Vogtle Project

March 26, 1985

NRC DOCKET NUMBERS 50-424 AND 50-425
CONSTRUCTION PERMIT NUMBERS CPPR-108 AND CPPR-109
VOGTLE ELECTRIC GENERATING PLANT - UNITS 1 AND 2
REQUEST FOR SUPPLEMENTAL INFORMATION
STATUS MEETING - DSER OPEN ITEMS

OPEN ITEMS INDEX: MARCH 20-22 MEETING

FIGURE 430.12-1

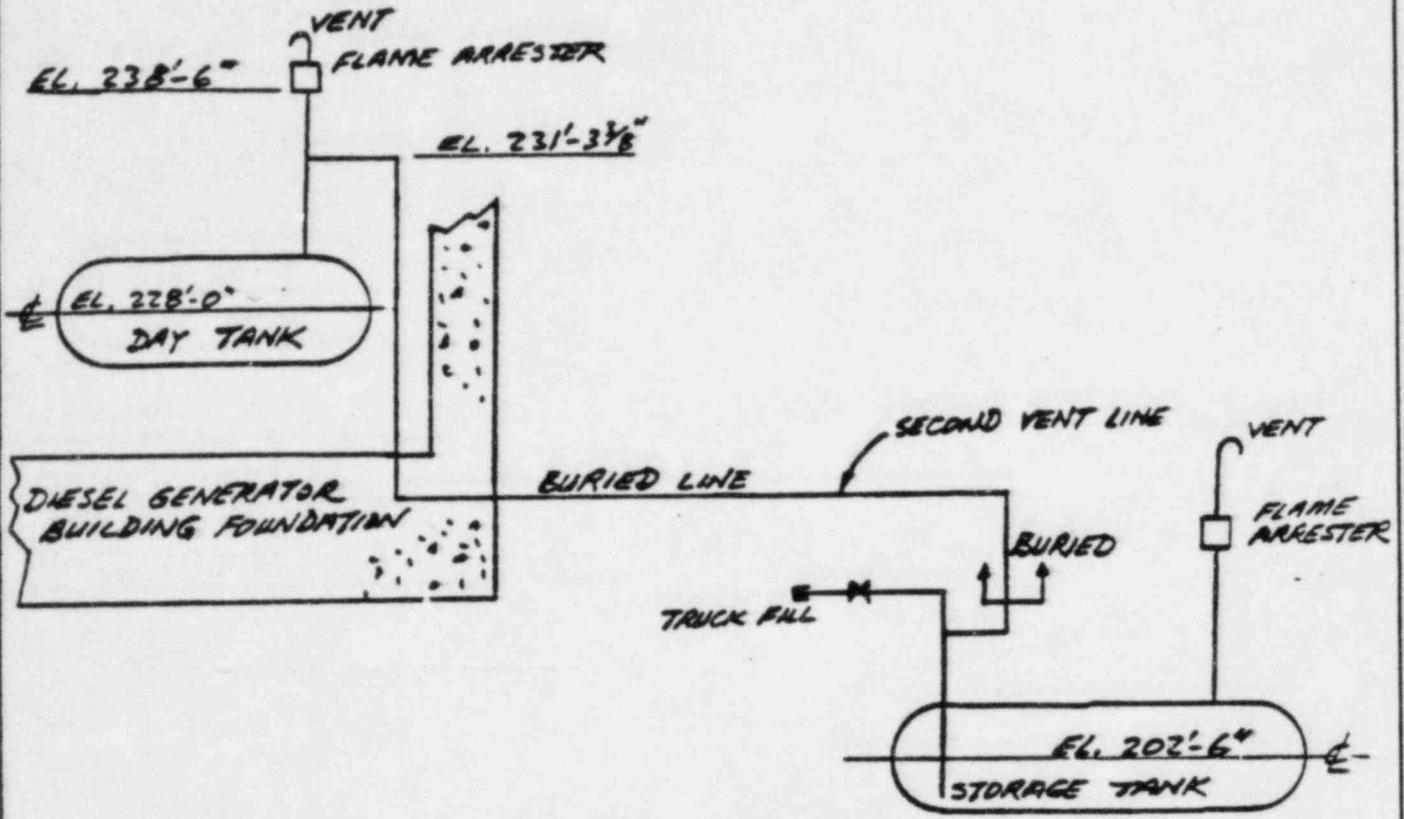
In the FSAR, you state that the fuel oil storage tanks are vented to the "valve house" located between the storage tanks. Expand your FSAR to provide additional information on the design features of this "valve house" which ensure adequate ventilation of the structure so as to preclude a buildup of combustible gases and the provisions to prevent the ventilation capability being blocked as a consequence of any weather condition.

Two 4-in., U-bend vents are provided on the roof of the valve house to provide redundancy in ventilation under the most adverse weather conditions. Similarly, two 4-in., U-bend vents are provided on the roof of each diesel fuel oil storage tank pumphouse.

The storage tank is vented in two separate locations. One is located outside of the valve house as shown in figure 430.12-1 and the second is through a branch line from the 4-in. truck fill line to the diesel fuel oil day tank vent line as shown in figure 9.5.4-1 of the FSAR.

NOTE: THE SECOND VENT LINE OUTSIDE THE DIESEL GENERATOR BUILDING AND THE FUEL OIL STORAGE TANK BUILDING IS BURIED. THE LOWEST PORTION OF THIS VENT LINE IS AT EL. 210'-1 1/4".
